**Carrier/Carlyle
5H40,46,60,66,80,86 Compressors
Conversion from Standard to Electric Unloading**

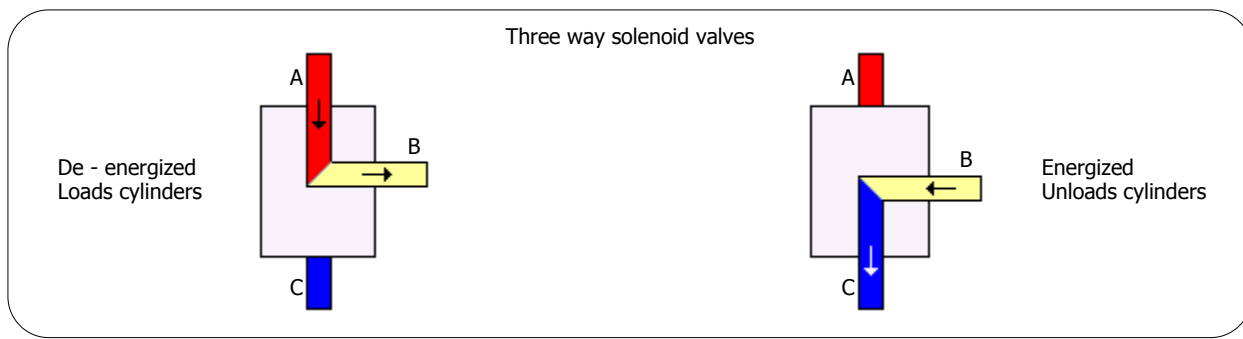
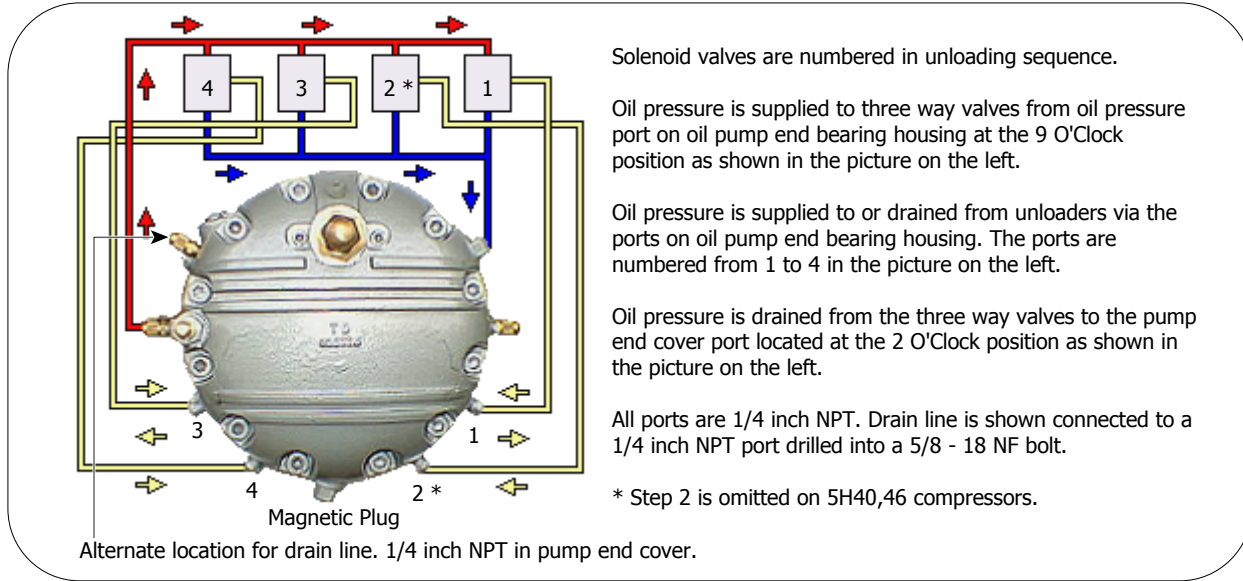
In order for these modifications to work the oil pump bearing housing must be factory drilled and tapped at the 4 O'Clock, 5 O'Clock, 7 O'Clock, and the 8 O'Clock positions on the outer rim as shown.

1. Remove pump end cover only.
2. Using pump end cover gasket as a guide, make a blank metal disc (1/32 to 1/16 inch thick), making holes for bolts only.
3. Reinstall pump end cover using two new gaskets, one on each side of the blank metal disc. This isolates the capacity control cover.
4. Mount solenoid valves and run oil lines.
5. To minimize vibration, mount valves on a bracket attached to the compressor. The following three way valves have been used in the field and are listed as a guide:

Alco Controls No. 702RA001
Alco Controls No. S608-1
Sporlan Type 180
